Lot: SV PH1 15

Model: Custom Elev A Murry (1015)

Date: January 24, 2024

VALECRAFT HOMES (2019) LIMITED

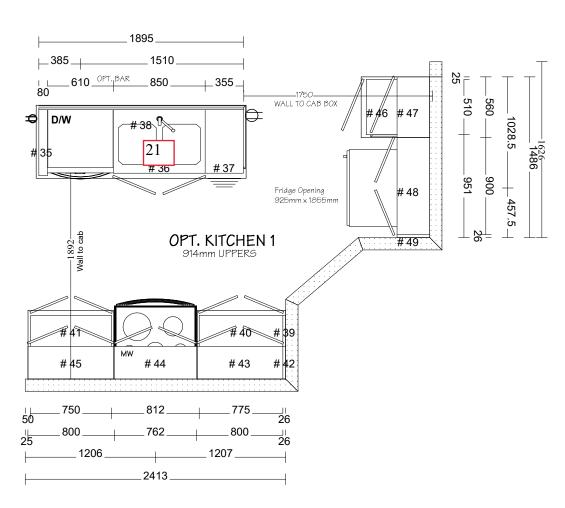
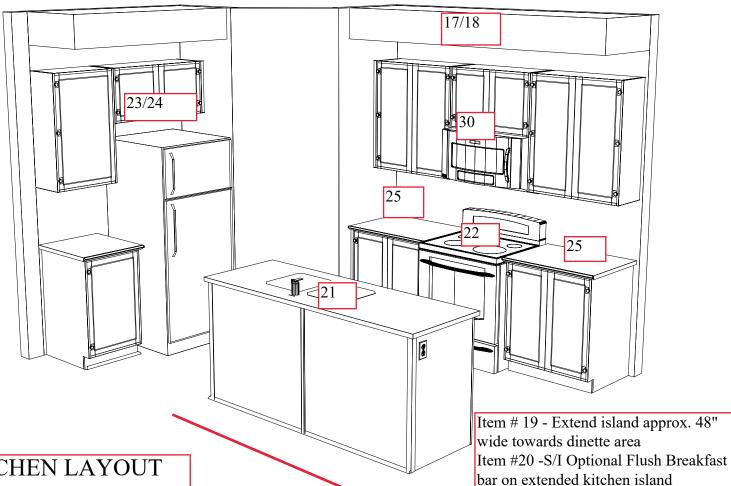
ITEM #14 - OPTIONAL KITCHEN LAYOUT (Final Kitchen sketch to be completed and will be sent to client for

Item #28 - Install 2 tone kitchen cabinets

Item #21 - Relocate sink, dishwasher and cutlery drawer in kitchen island to shift approx 12" to 30" to sink is aligned as best as possible with oven opening. Bank of drawers to be closest to the sink Item #22 - Shift oven space location approx. 12" toward dinette to be approx aligned with new sink location in kitchen

Item # 26 - LC pots and pans c/w drawe front 6/12/12- to be located in the island towards the dinette (end run of island)
